SUBJECT: Forwards for review as proposed FSAR changes, proposed CESSAR changes re justification for LPSI & HPSU pump flow reductions, supplementing 841218 ltr.

Subject: Palo Verde Nuclear Generating Station (PVNGS)
Units 1, 2, and 3
Docket Nos. STN 50-528/529/530
Post-FDA Proposed CESSAR Changes
File: 84-056-026; G.1.01.10

Subject: High Pressure Safety Injection Flow

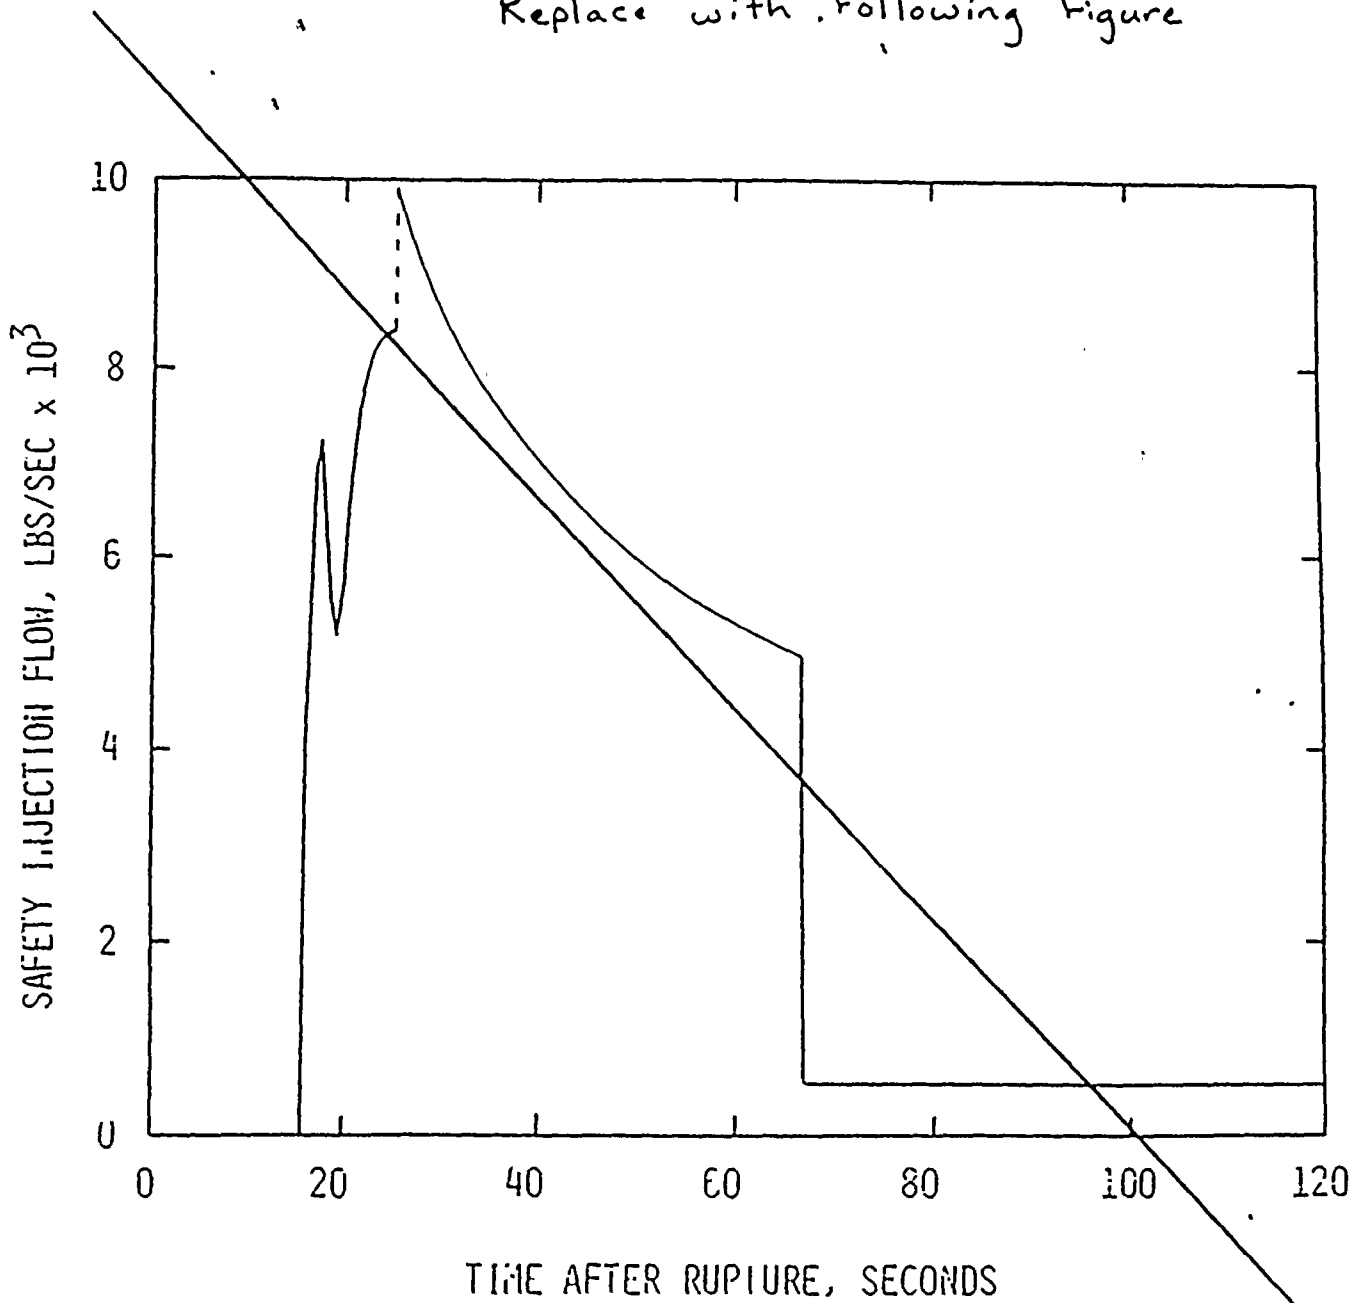
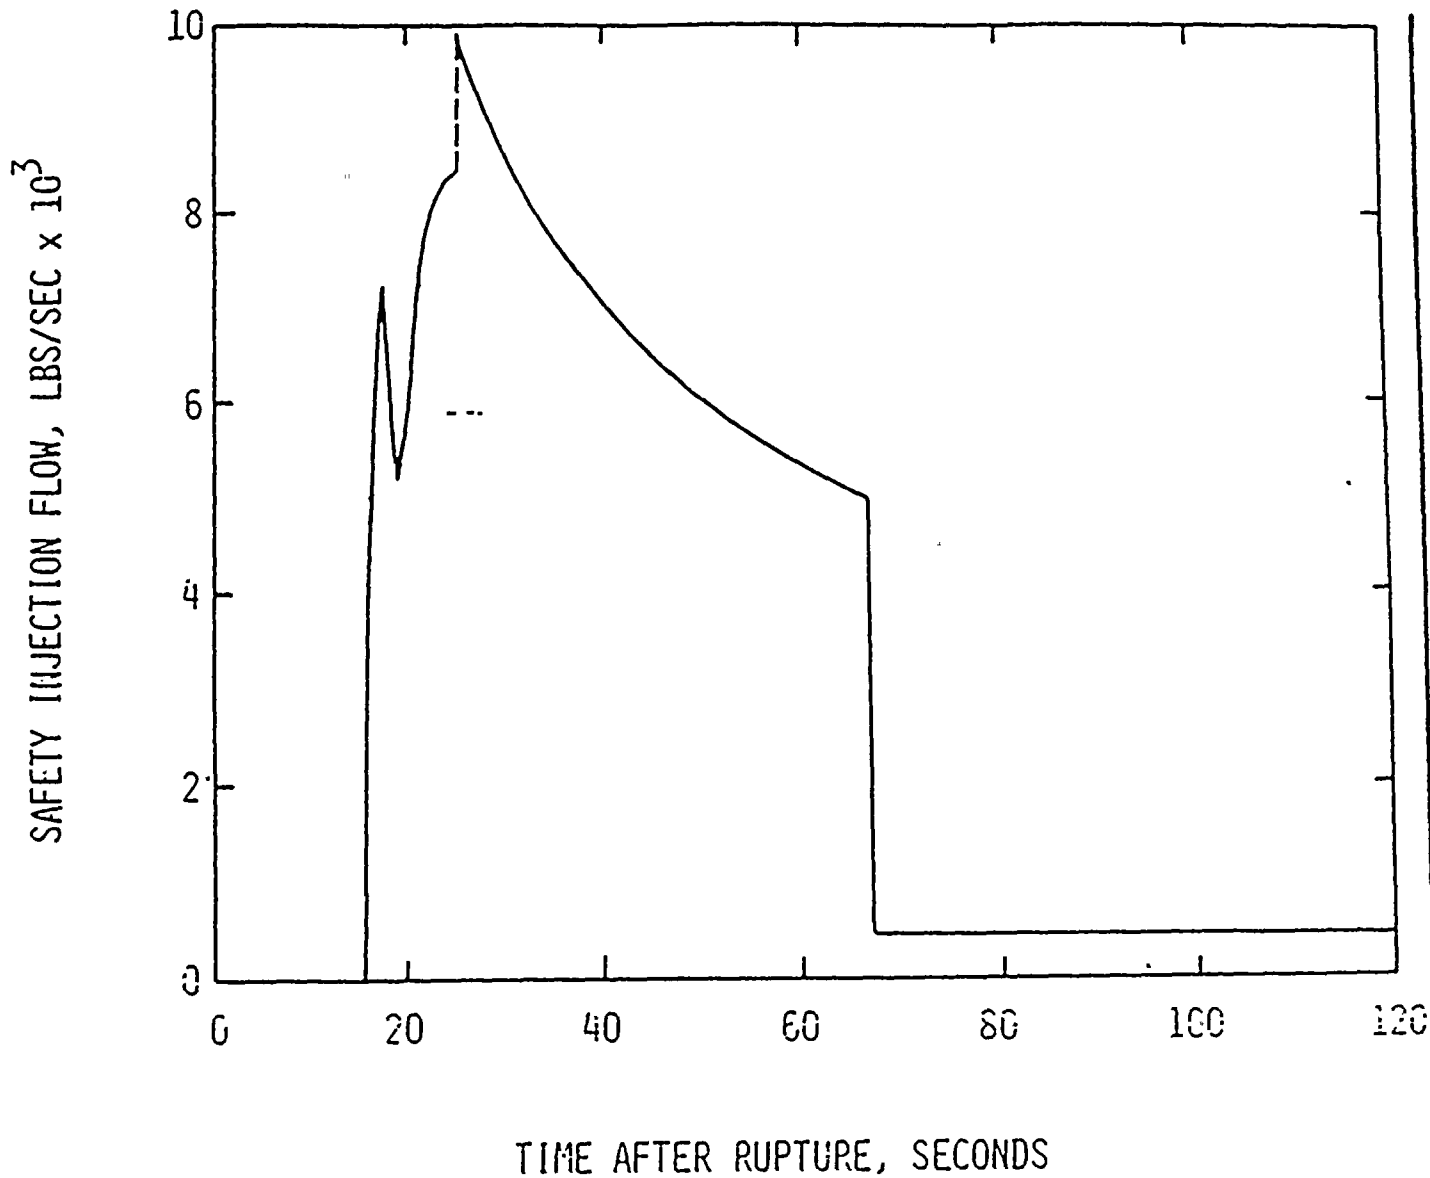
Replace with following figure

FIGURE 1
0.05-FT² BREAK -- REDUCED HPSI PUMP DELIVERY
PEAK CLAD TEMPERATURE

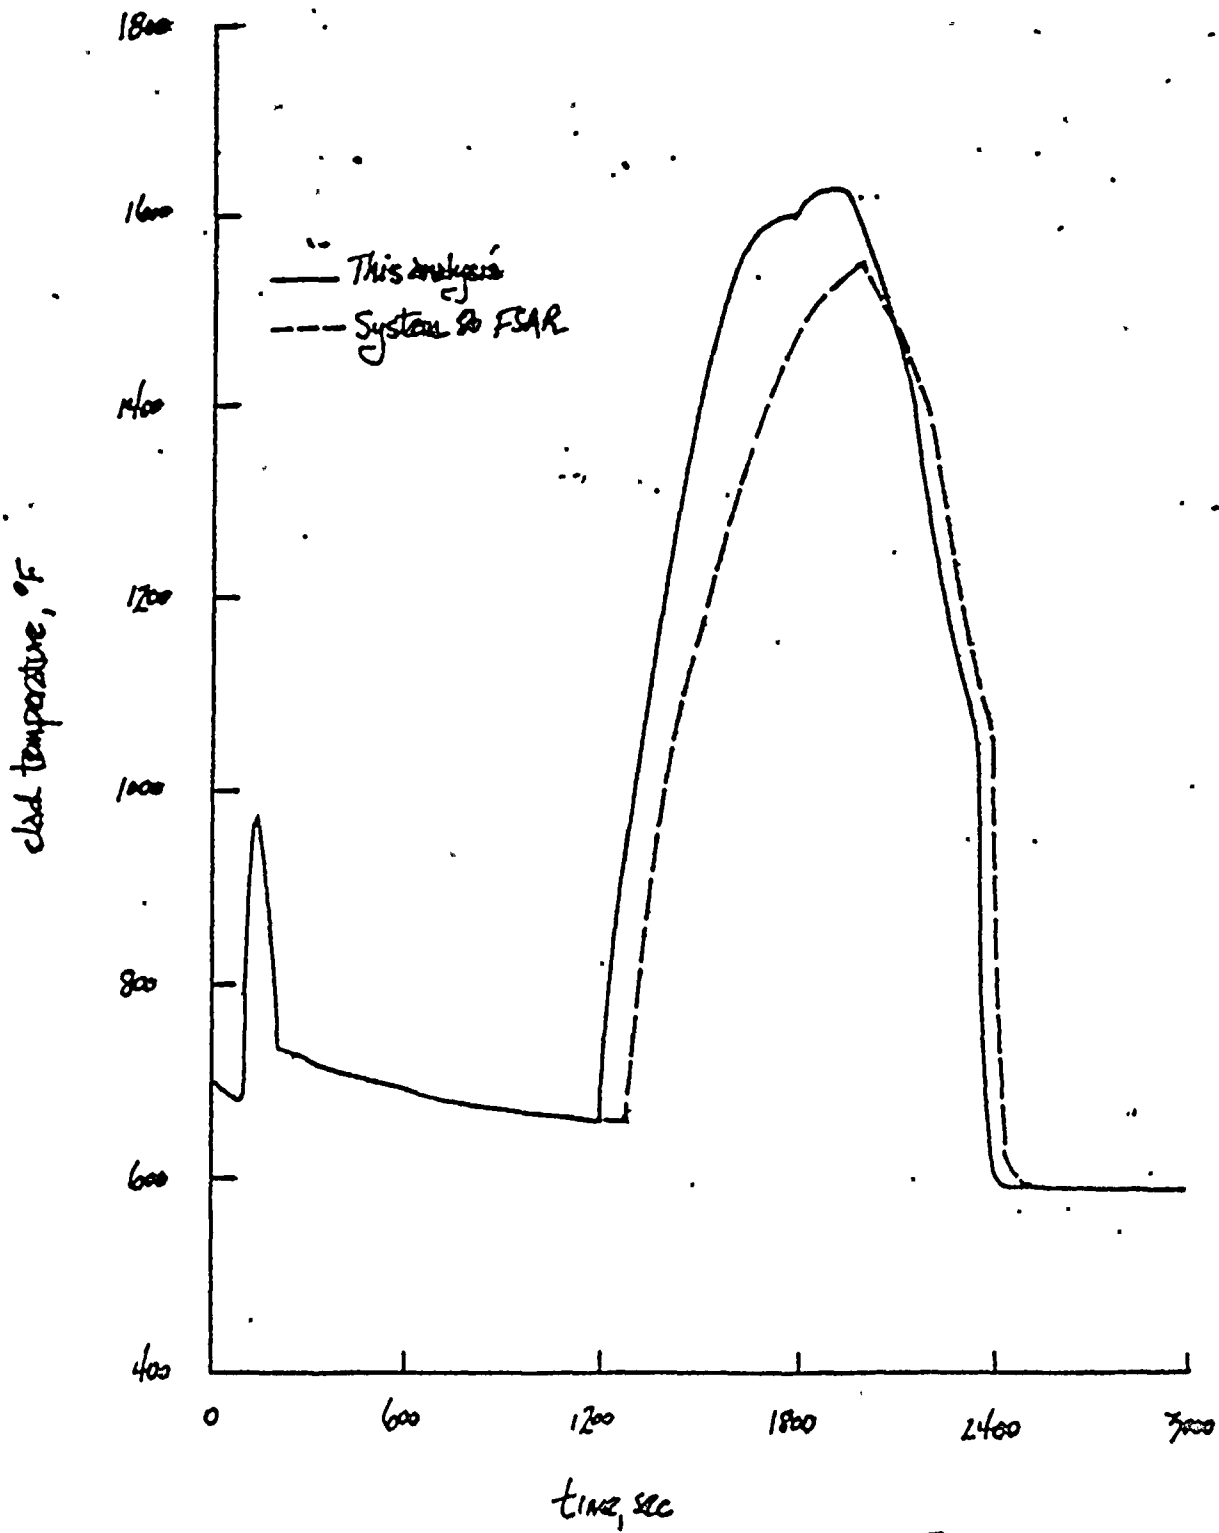
A comparison of the previous peak clad temperature and two-phase mixture height in the core is attached (Figures 1 and 2). Also attached is a CESSAR change that is provided for your review. It will be incorporated into CESSAR in the next amendment.

A review of Figures 1 and 2 indicates that the maximum peak clad temperature for this break size increased from 1557°F (from previous CESSAR analyses) to 1630°F. This increase is attributed to the slightly longer period of core uncovering resulting from the decrease in HPSI flow delivered. This small break analysis is still conservatively bounded by the most limiting large break LOCA peak clad temperature (2169°F occurs in a 1.0 ft² double-ended cold leg guillotine break).

In summary, a CESSAR change is forwarded to reflect a reduced HPSI pump flow. This change was necessary due to as-built conditions in the first System 80 plant. A re-analysis of the most limiting small break LOCA demonstrates that system performance remains well within the acceptance criteria of

10 CFR 50.46. Additionally, the higher resulting peak clad temperature remains at least 500°F below the limit case large break LOCA.
